ENVIRONMENTAL BOARD MOTION FORM

Agenda Item: 6a. Barton Springs Pool General Grounds Improvements SPC-2012-0104D

**BARTON SPRINGS POOL
GENERAL GROUNDS
IMPROVEMENTS
2201 BARTON SPRINGS ROAD
SPC-2012-0104D**

South Sidewalk Improvements

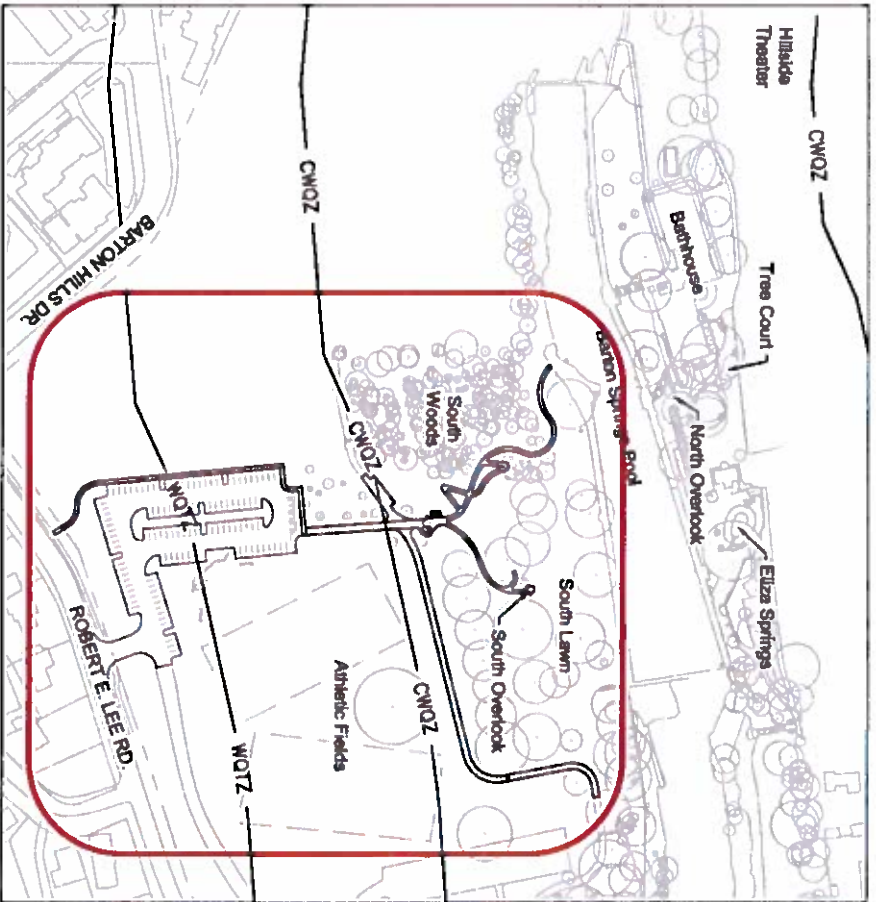
1. Removal of the walkway to the "overlook" on the south lawn;
2. Removal of existing impervious cover in another area of the Barton Springs site as mitigation for the construction of the concrete parking lot in the Water Quality Transition Zone of Barton Creek, with the goal of no increase in the percentage of impervious cover in the Barton Springs Zone.

As for the "overlook" on the south lawn, there are other options to accomplish providing a view of the pool for persons with disabilities, such as preparing the turf near the ticket booth on the south lawn in a manner that would allow access for wheelchairs. Otherwise, there is more than adequate provision for ADA access in the planned construction of an ADA compliant trail that goes to the diving board area of the pool from the south entrance to the pool.

Construction of a walkway to the "overlook" area on the south lawn is not recommended, since there is already provision for an ADA compliant trail from the south entrance to the pool that will give ample opportunities to view the pool from a number of vantage points.

South Entry Parking Lot and Water Quality Improvements

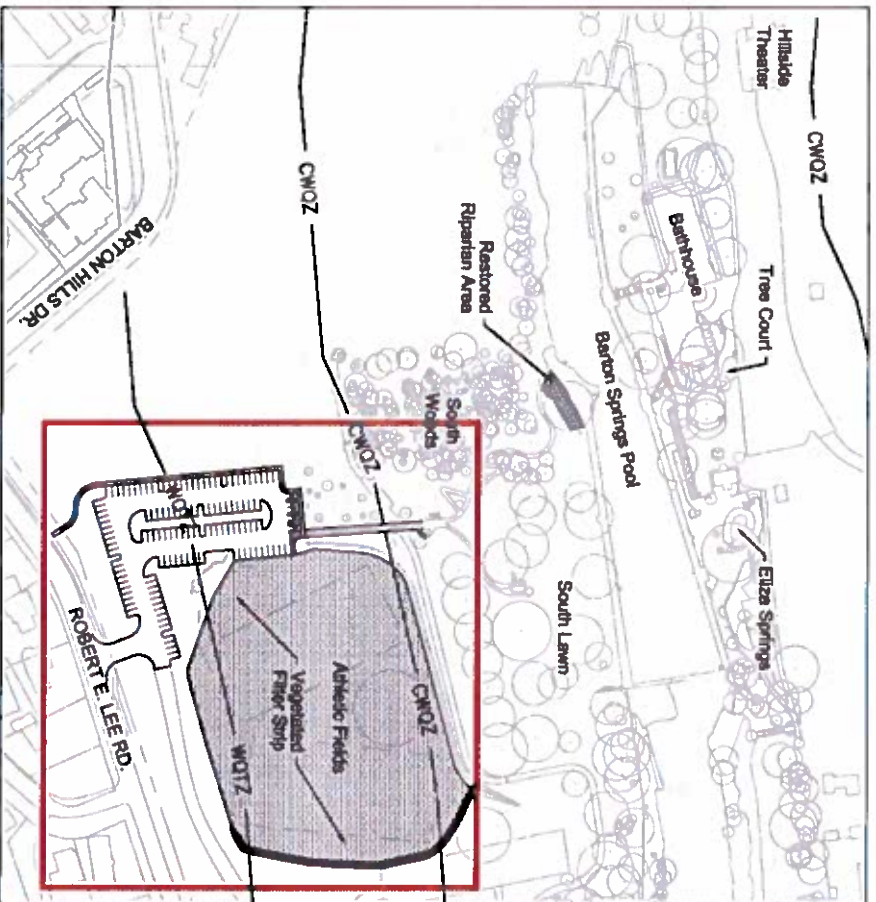
As for the need to further mitigate for the impervious cover associated with the concrete parking lot, the Board recommends removing a portion of existing impervious cover somewhere on the site of Barton Springs Pool in order to more closely comply with the 15% impervious cover requirement in the Critical Water Quality Zone

and the Water Quality Transition Zone of Barton Creek. The goal should be to remove existing impervious cover in the area at every opportunity at Barton Springs Pool. The Board also recommends that the Parks Department partner with the Watershed Protection Department to accomplish this mitigation recommendation.

1. Removal of the walkway to the "overlook" on the south lawn;
2. Removal of impervious cover from somewhere on the site of Barton Springs Pool as mitigation for the construction of the concrete parking lot in the Water Quality Transition Zone in order to maintain and not increase impervious cover, and to adhere more closely to the Master Plan for Barton Springs.
3. Recommend the use of rain gardens, bioswales and other advanced stormwater controls on the site in order to enhance water quality at Barton Springs and Barton Creek.

One of the goals of the Watershed Protection Department is to improve water quality on Barton Creek and to retrofit areas that contribute to lower water quality. The Board supports that goal and, for that reason, recommends the removal of impervious cover as a condition for approval of the construction of the parking lot in the Water Quality Transition Zone. The Board also recommends that advanced stormwater controls be utilized, wherever feasible, on the site. The Board urges the Parks Department and the Watershed Protection Department to partner in impervious cover removal and utilization of state of the art stormwater controls that would improve water quality at Barton Creek.

- *Restore soil and site.*
- *Provide additional native landscaping than otherwise required.*
- *Provide water quality control for existing and new impervious cover associated with the parking lot.*
- *Maintain the water quality control as described in the maintenance agreement.*
